LETTER AND U S NAVY RESPONSE TO REGULATOR COMMENTS REGARDING DRAFT
SAMPLING AND ANALYSIS PLAN ADDENDUM CODDINGTON COVE RUBBLE FILL AREA
NS NEWPORT RI
8/5/2013
RESOLUTION CONSULTANTS

RE: Responses to Comments
Draft Sampling and Analysis Plan (SAP) Addendum
Coddington Cove Rubble Fill Area (CCRF), Naval Station (NAVSTA) Newport,
Rhode Island

**NAVY RESPONSES TO
U. S. ENVIRONMENTAL PROTECTION AGENCY (EPA)
COMMENTS DATED JUNE 13, 2013
ON THE DRAFT SAMPLING AND ANALYSIS PLAN ADDENDUM,
CODDINGTON COVE RUBBLE FILL (CCRF) AREA (IR SITE 4)
NAVAL STATION (NAVSTA), NEWPORT, RHODE ISLAND**

**NAVY RESPONSES TO
RHODE ISLAND DEPARTMENT OF ENVIRONMENTAL MANAGEMENT (RIDEM)
COMMENTS DATED JUNE 27, 2013
ON THE DRAFT SAMPLING AND ANALYSIS PLAN ADDENDUM,
CODDINGTON COVE RUBBLE FILL (CCRF) AREA (IR SITE 4)
NAVAL STATION (NAVSTA), NEWPORT, RHODE ISLAND**

Image 1

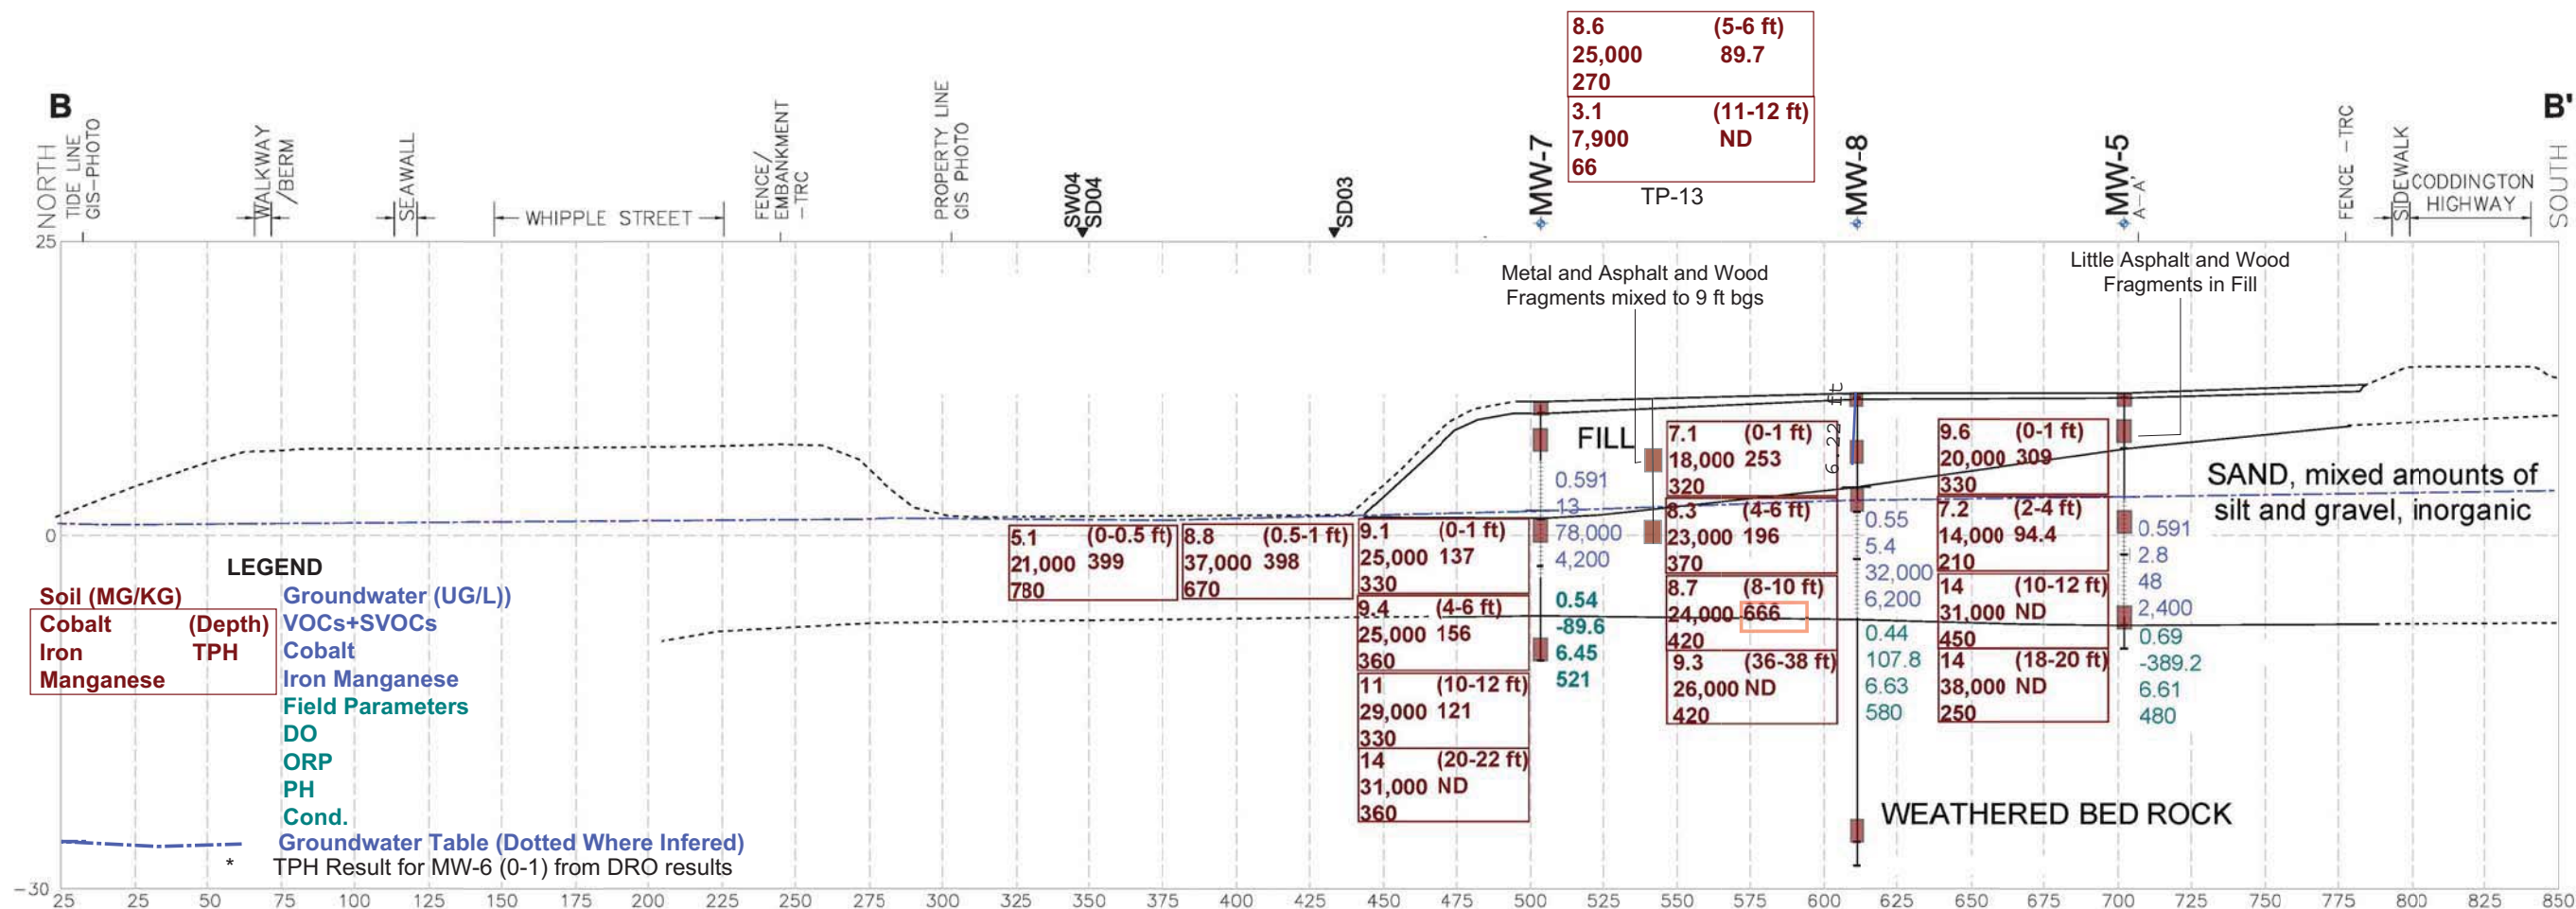
***General Comment 1:** The SAP Addendum should provide a summary of the data from the Revised Draft SASE on the levels of metals in groundwater for the 5 metals identified as posing potential risks. The summary should document the maximum, minimum and average concentrations; the project action limit (PAL) and the basis for the PAL; a summary of the risk conclusions for the metals of concern; and, a comparison to likely cleanup goals including MCLs. A figure should also be provided showing the concentrations of the elevated metals at the existing wells, including an explanation of whether certain wells or areas of the site generally represented the most elevated groundwater conditions. The geochemical data collected during the SASE should also be summarized and discussed in relation to the elevated metals of concern.*

***General Comment 1:** Please include in this SAP Addendum a discussion of the previous groundwater data for arsenic, chromium, cobalt, iron and manganese, and include a summary of this data on a figure.*

Response: Agreed. A discussion of prior results for As, Cr, Co, Fe, and Mn detected in groundwater will be added to Worksheet #10 Conceptual Site Model. A representative site cross-section has also been created to present this information, which will be incorporated into the SAP Addendum. Refer to the attached images.

Prior analytical results of TPH, selected metals, and selected field parameters have been plotted on a site cross-section. Refer to the attached images. In addition, historic aerial photos are being obtained to help refine the estimated extent of rubble disposal and possible historic wetlands within the site. The aerial photos, geologic logs, and prior analytical results and field parameters will be used to help refine the CSM relative the presence, possible sources, behavior of target metals in the subsurface, and eventually complete the SASE process of site evaluation. If actionable risks are present at the completion of the SASE, site information can then be used to assess further actions via an FFS (e.g., MNA, etc.).

Response: Agreed. A discussion of prior results for As, Cr, Co, Fe, and Mn detected in groundwater will be added to Worksheet #10 Conceptual Site Model. A representative site cross-section has also been created to present this information, which will be incorporated into the SAP Addendum. Refer to the attached images.
